NEW MEXICO OIL CONSERVATION DIVISION
- Engineering Bureau -

APPLICATION FOR AUTHORIZATION TO INJECT

WELL NAME & NUMBER: Round Tank SWD #1

From: Jones, William V., EMNRD
Sent: Monday, March 09, 2009 9:56 AM
To: 'Jerry Sherrell'
Cc: Ezeanyim, Richard, EMNRD; Reeves, Jacqueta, EMNRD; Warnell, Terry G, EMNRD; Bonham, Sherry, EMNRD
Subject: Disposal Application from Mack: Roundtank SWD #1 Unit K, Sec 19, T15S R29E Chaves County Devonian Disposal

WELLBORE SCHEMATIC

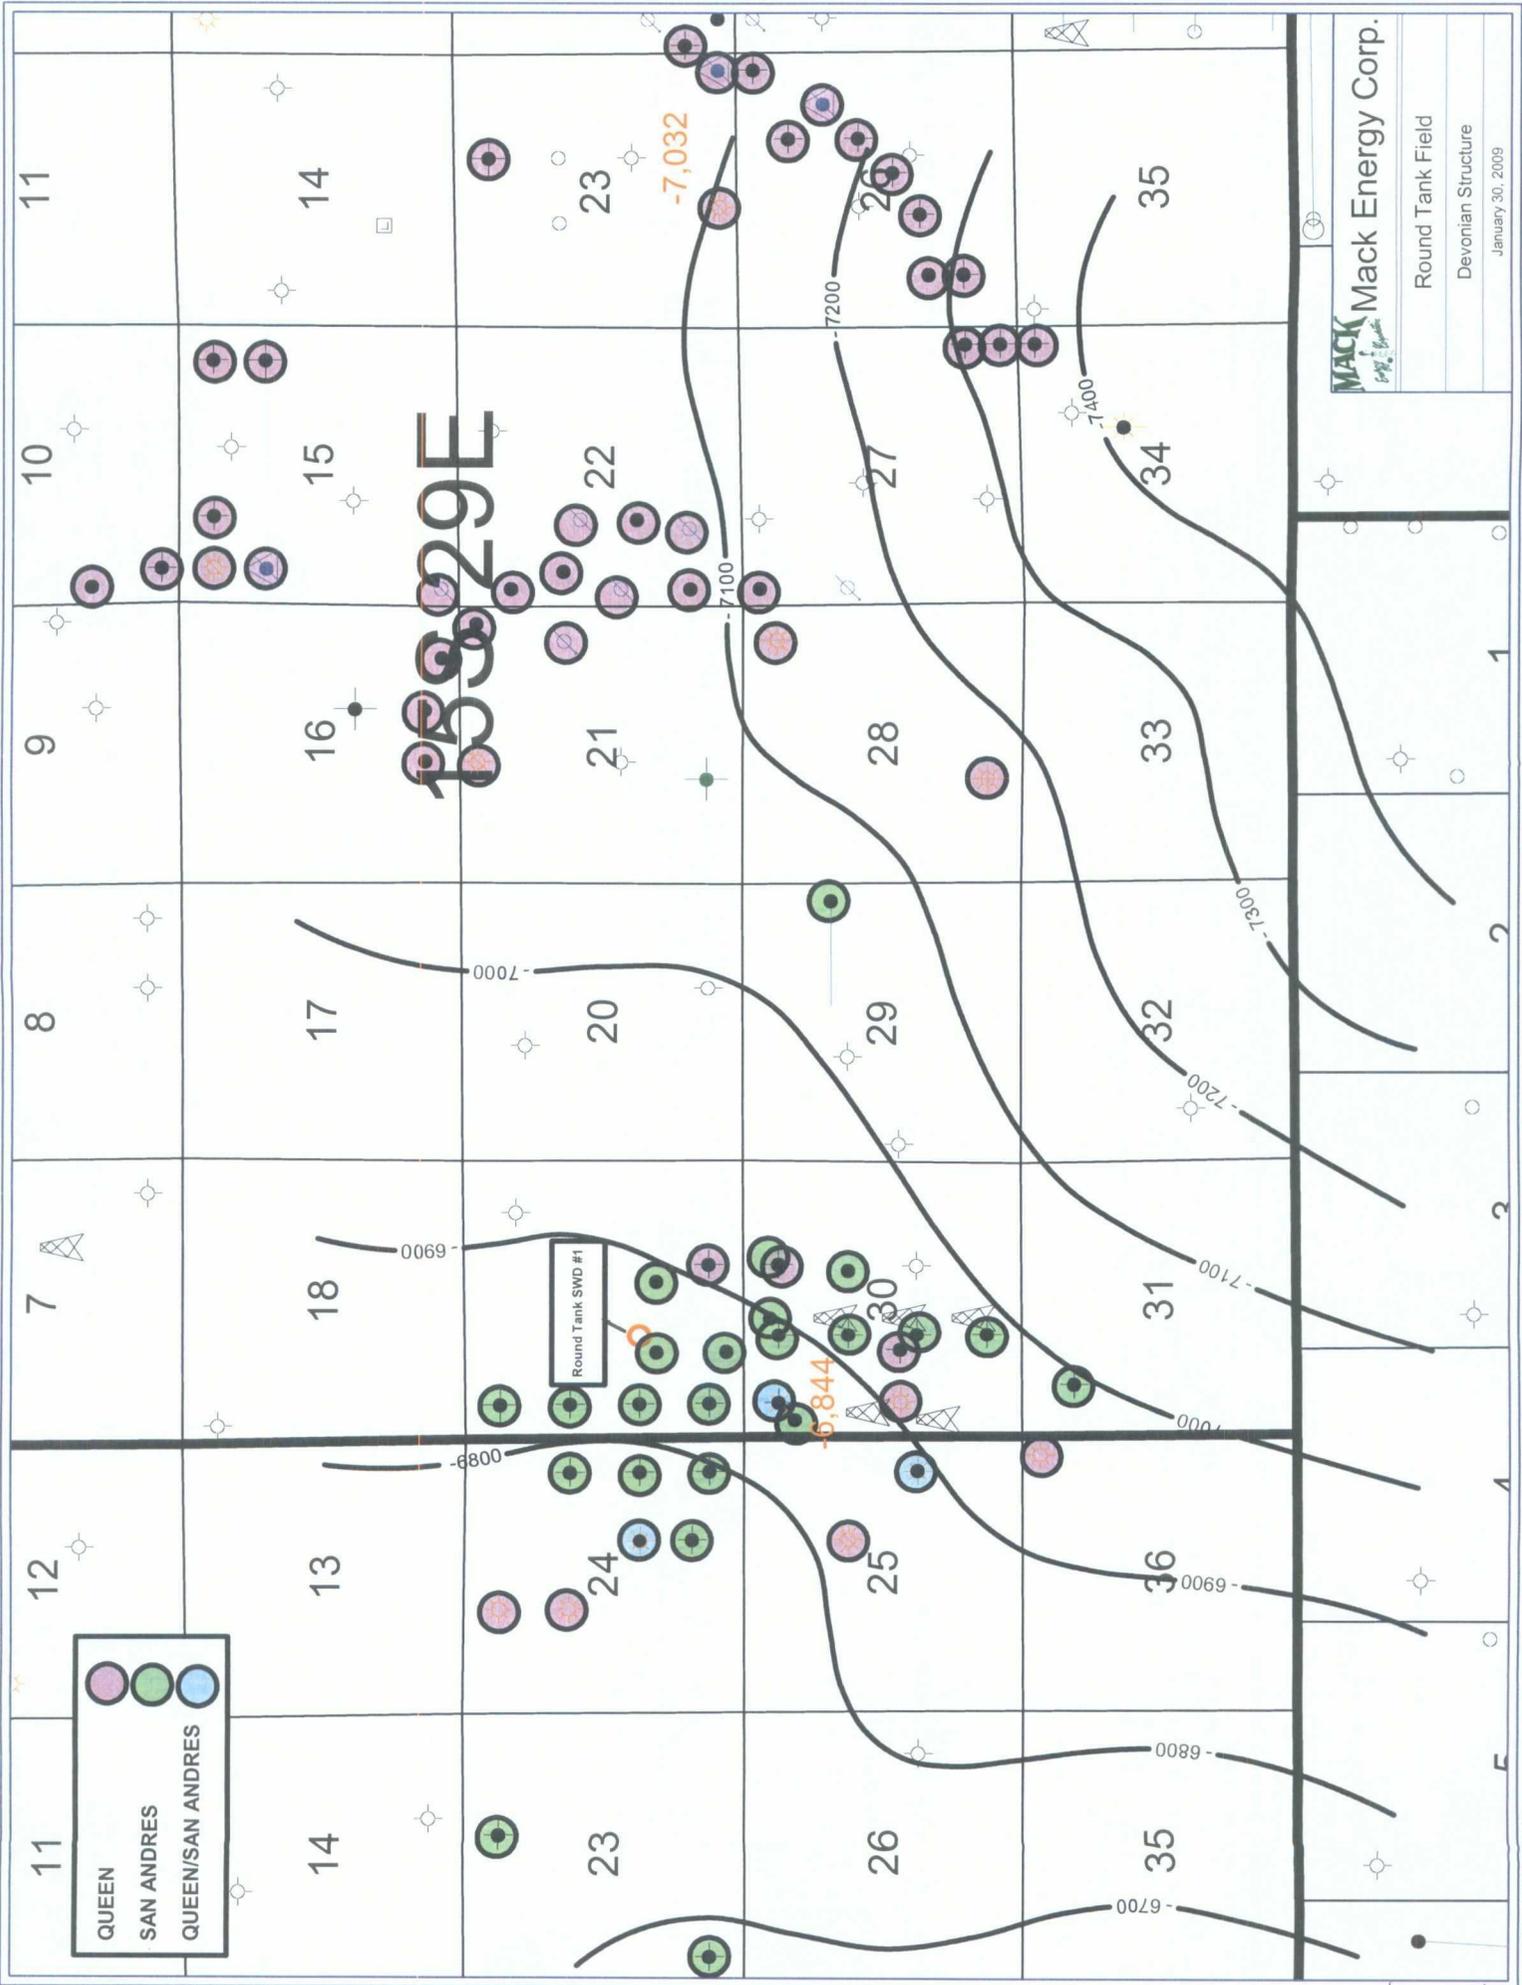
- 2) The proposed intermediate pipe at 1800 feet would only cover the Queen producing interval. The San Andres is producing from 2950 to 3230 in an offset well and the Glorieta top is at 3700 feet. Your application did not say where the DV tool would be on the 5-1/2 inch casing. Please install a DV tool at 3700 feet or otherwise ensure the San Andres corrosive intervals and productive intervals are covered with cement (or as directed by the Artesia district office). Let me know?

Will,
1) Attached is the API number for this well.
2) Cement will be circulated to surface. We did not specify where the DV tool will be set, due to the fact we could have a possible wash out. The drilling dept. would like to see the logs and possible lost circulation zones dictate where the DV tool(s) are set.
3) There are no fresh water wells within a mile of this location.
